MEMORANDUM

Muncaster Mill Road (MD115) Improvements

Mandatory Referral No. MR# 02814-SHA-1

RECOMMENDATION: APPROVAL WITH COMMENTS TO SHA

ATTACHMENT 2

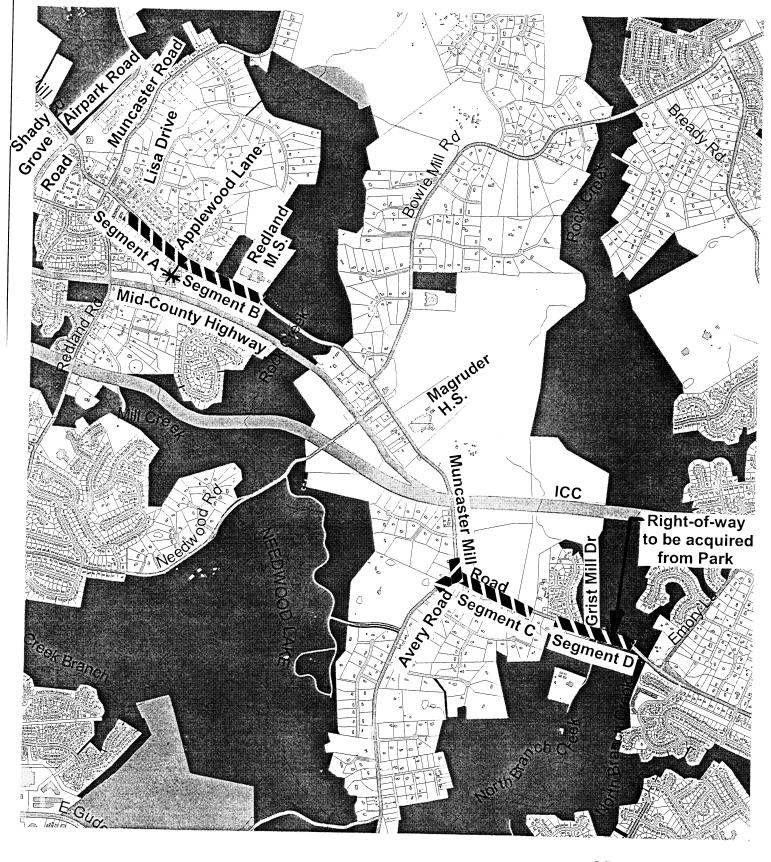
The project would construct safety improvements at four locations within the project limits, described below as Segments A, B, C and D and shown in Attachment 2. The total length of the project is approximately 8,200 feet.

Segment A: Muncaster Mill Road from west of Lisa Drive to Applewood Lane (a distance of approximately 1,850 feet) would be widened to include a center-turn lane and four-foot wide bike-accessible shoulders, and would include the construction of an eight-foot hiker-biker trail on the south side of the road as recommended in the Upper Rock Creek Master Plan.

Segment B: Muncaster Mill Road from Applewood Lane to Redland Middle School (a distance of approximately 2,000 feet) would be resurfaced with a high friction asphalt to increase skid resistance, and would include the construction of a five-foot sidewalk on the north side of the road to the school's western driveway.

Segment C: The horizontal alignment of Muncaster Mill Road at Avery Road would be shifted about fifty-five feet to the north to flatten the curve and improve sight distance. A sharp vertical curve in the road about 1,300 feet east of the Avery Road intersection would be flattened, reducing the elevation by about five-and-a-half feet. About two hundred fifty feet of Avery Road would be reconstructed. Bike-accessible shoulders would be constructed throughout the segment, for a distance of 2,050 feet.

Segment D: A left-turn lane would be constructed for eastbound Muncaster Mill Road traffic at Grist Mill Drive. The segment limits would be from 800 feet east of Grist Mill Drive to 1,500 west of the intersection, at the bridge over the North Branch of Rock Creek. Two vertical curves within the segment limits would also be improved.

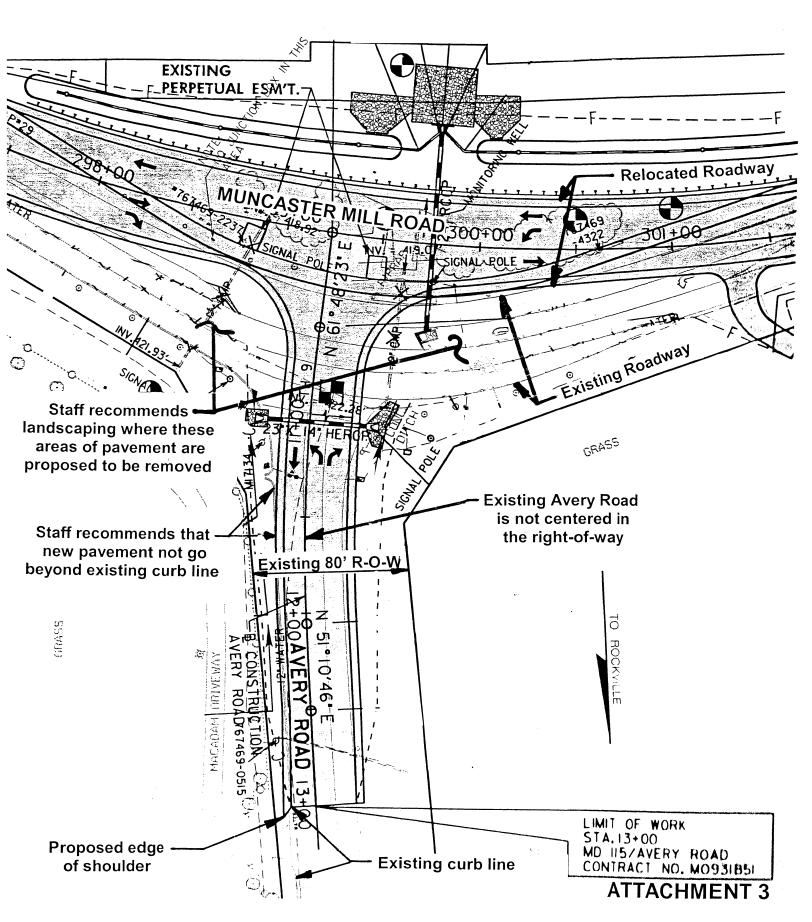
Within the limits of work, Avery Road would be widened to include four-foot-wide bike-accessible shoulders. This widening would bring the edge of pavement closer to the northern right-of-way line (see Attachment 3). Although the right-of-way of Avery Road is eighty-feet wide, appropriate to its arterial classification, the roadway is not centered in the right-of-way; the edge of the travel lane is only about 8.5 feet from the northern right-of-way line, rather than the normal twenty-eight feet. The proposed design would eliminate the existing curb and would provide a ditch between the edge of pavement and the right-of-way line/fence line. Staff recommends that SHA consider altering the proposed tie-in to Avery Road so that the revised edge of pavement is no closer to the northern edge of pavement of Avery Road than existing, replacing the existing curb and leaving room for a future sidewalk.

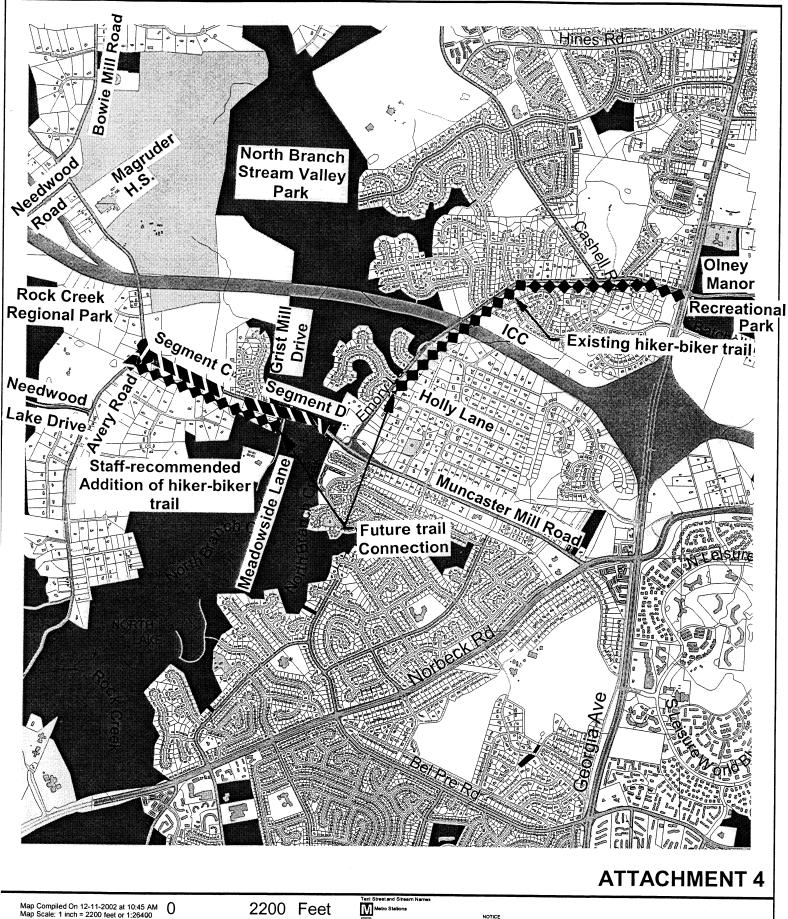
Staff recommends that SHA construct the Master Plan-recommended hiker-biker trail along the south side of Muncaster Road between Avery Road and Meadowside Lane to improve pedestrian and bicyclist safety and accessibility (see Attachment 4).

The terrain is very steep and the existing bridge cannot accommodate a trail. The bridge would have to be widened or replaced, or a new separate trail bridge would have to be built. All of these alternatives are beyond the scope of this project. Future extension of the trail to the east is desirable however to link up with the Emory Lane hiker-biker trail. That trail begins at Holly Lane (one block off Muncaster Mill Road) and continues to Georgia Avenue, opposite Olney Manor Recreational Park (see Attachment 4).

Staff agrees that the park impacts are acceptable to gain the needed safety improvements but recommends that SHA also construct the Master Planrecommended hiker-biker trail along the south side of Muncaster Road between Avery Road and Meadowside Lane as mitigation for these impacts. In addition to providing better accommodation along Muncaster Road for pedestrians and bicyclists, the recommended trail segment would provide a better connection between Rock Creek Regional Park and North Branch Stream Valley Park via Needwood Lake Drive and Avery Road (see Attachment 4).
